Subject ▶ Change on Torsion Spring 20 and Lever.

For Models ▶ UM401DW,AM4024LC

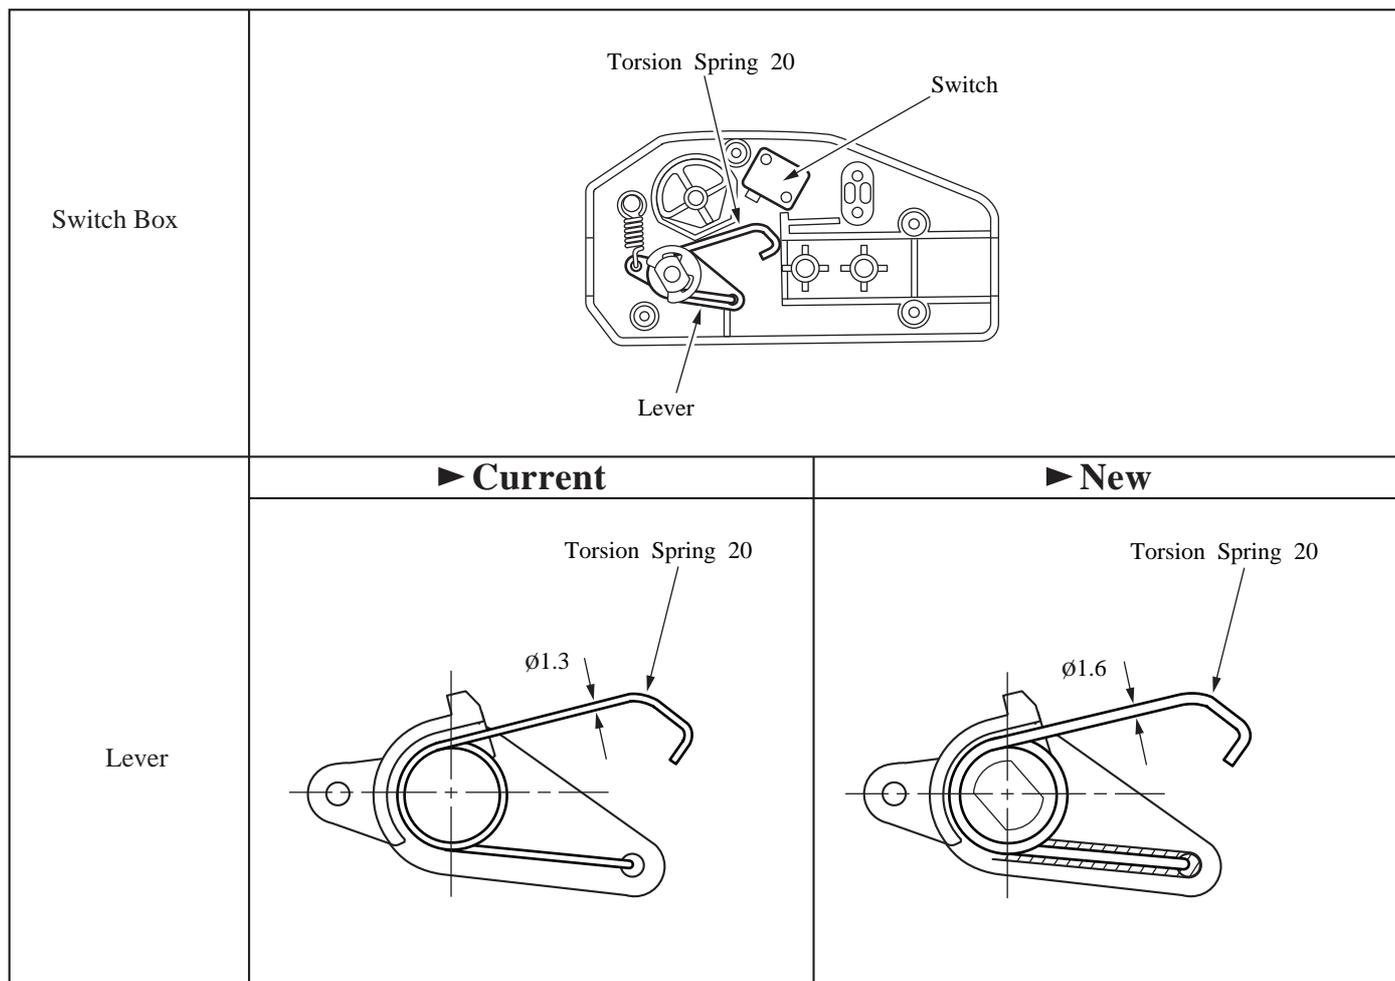
Description ▶ Following changes have been made.
 1. The diameter of Torsion Spring : $\phi 1.3\text{mm} \Rightarrow \phi 1.6\text{mm}$.
 2. Addition of gutter on Lever.

Item No.	Current part	Q'ty	I/C	New part	Q'ty	Note
58	Torsion Spring 20 231628-5	1	No	Torsion Spring 20 231639-0	1	↕ Interchangeable as a set ↕
59	Lever 416198-7	1	No	Lever 416627-0	1
